# Access Compliance Report

## Public Rights-of-Way

### (Curb Ramps)

Intersection ID: 15922	Main Street: LANIER_AV	Cross Street: GWYNNE_AV	Location: SE
ADA ID: 0FE1A0291F21	Ramp Type: Perp	Initial Pass/Fail: Fail	Overall Compliance: No
		Severity Score: 8.75	
Codes/Mitigation Info/Possible Solution		Field Measurements/Component Compliance

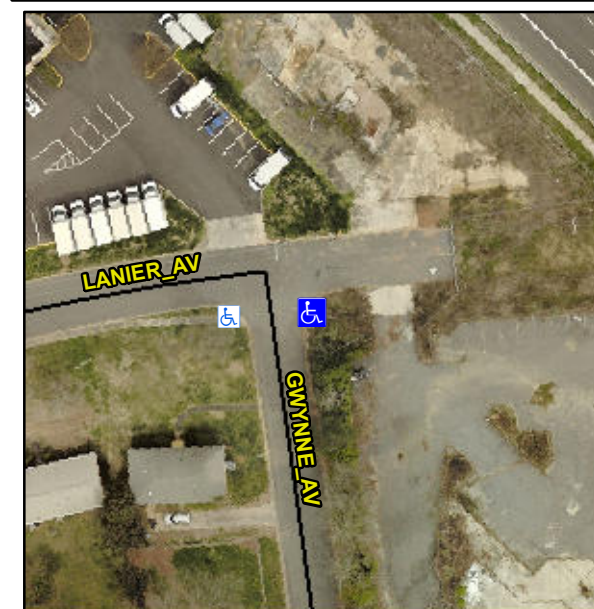
**Not Found, R304.5.1**

Compliance	Description	Data	Compliance	Description	Data
N/A	Ramp Length (in)	129.0	Yes	Ramp Slope (%)	5.1
No	Ramp Width (in)	38.5	Yes	Ramp XSlope (%)	1.5
N/A	Flare Type LT	N/A	N/A	Flare Type RT	N/A
N/A	Flare Slope LT (%)	N/A	N/A	Flare Slope RT (%)	N/A
N/A	Flare Traversable LT?	N/A	N/A	Flare Traversable RT?	N/A
N/A	Landing Length (in)	N/A	N/A	DWS Provided?	N/A
N/A	Landing Width (in)	N/A	N/A	DWS Contrast?	N/A
N/A	Landing Slope (%)	N/A	N/A	DWS Length (in)	N/A
N/A	Landing X Slope (%)	N/A	N/A	DWS Full Width?	N/A
N/A	Landing Curb? (Y/N)	N/A	N/A	DWS Offset (in)	N/A
N/A	Shared Landing?	N/A			
N/A	Gutter Ponding?	N/A	N/A	Gutter Slope (%)	N/A
N/A	Gutter Lip Ht (in)	N/A	N/A	Gutter X Slope (%)	N/A
N/A	Painted X Walk1?	No	N/A	Painted X Walk2?	N/A
	X Walk 1 Direction	To W		X Walk 2 Direction	N/A
N/A	X Walk 1 Width (in)	N/A	N/A	X Walk 2 Width (in)	N/A
	X Walk 1 Slope (%)	2.3		X Walk 2 Slope (%)	N/A
	X Walk 1 X Slope (%)	2.1		X Walk 2 X Slope (%)	N/A

**Remove & Replace Entire Ramp.**
